FICHTNER

Kronospan Limited

Schedule 5 Response #4

Figure 1: Updated Figure 7 – Annual Mean Nitrogen Dioxide PC – Normal Operations – Likely Emissions

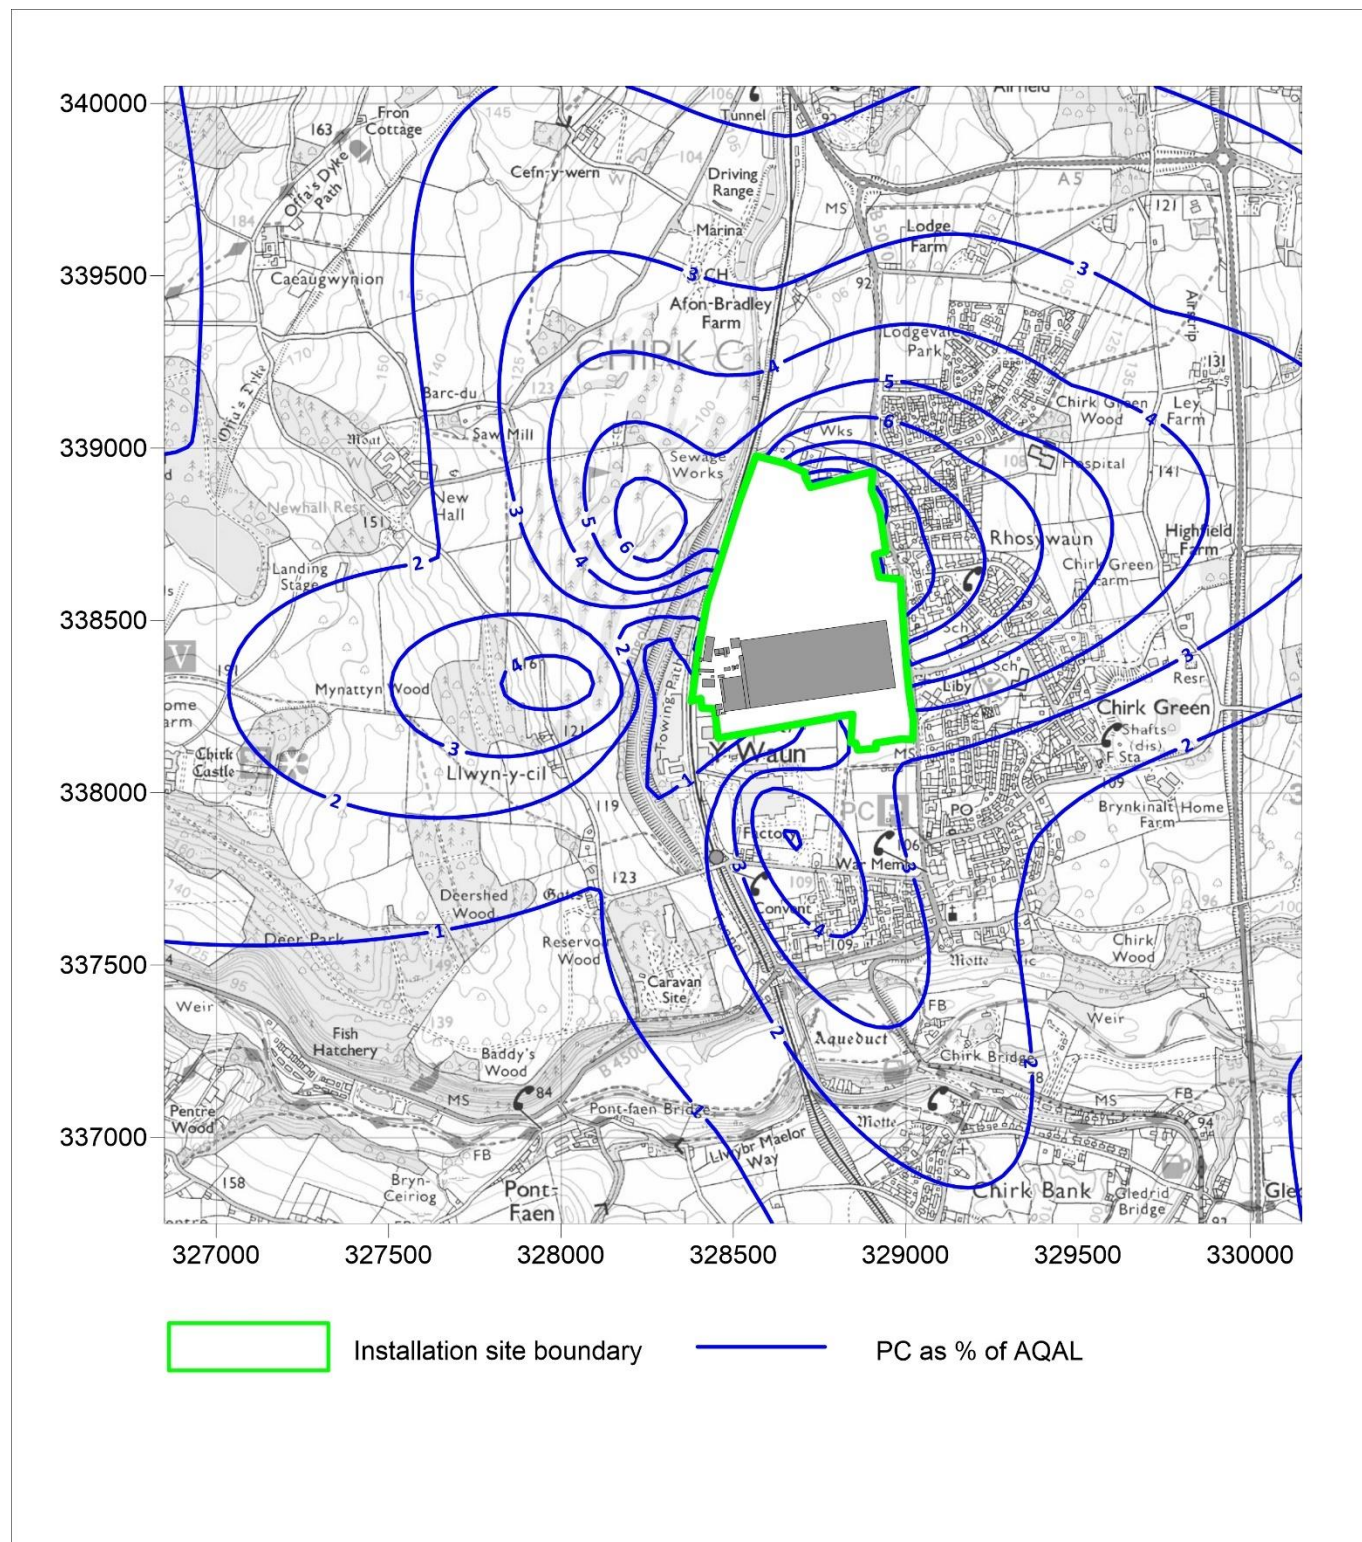
On this basis, please amend the air quality dispersion modelling assessment for the overall site, so that it reflects a modelled value of 200 mg/Nm³ NO_x for K1. More specifically, the process contribution associated with the proposed value of 200 mg/Nm³ shall be added to predicted releases of annual and short-term NO_x from all other sources on site and the site's overall impact on human health and habitats (critical levels and loads) shall be reassessed. The re-assessment shall consider both current site operations and proposed operation scenarios.

The dispersion modelling assessment has been updated to reflect the assumed operation of the K1 boiler with a NO_x ELV of 200 mg/Nm³ (3% reference oxygen content), which equates to a release rate of 0.208 g/s.

Updated figures have been produced, refer to Appendix A, which account for the revised emissions from the K1 boiler:

- Updated Figure 7: Annual Mean Nitrogen Dioxide PC – Normal Operations – Emissions
- Updated Figure 8: Annual Mean Nitrogen Dioxide PC – Normal Operations – Worst-Case Emissions
- Updated Figure 9: 99.79%ile of 1-hour Nitrogen Dioxide PC – Normal Operations –Likely Emissions

As shown the inclusion of the K1 boiler is predicted to have a slight impact on the distribution of emissions of oxides of nitrogen. However, the conclusions of the assessment submitted with the EP application do not change.
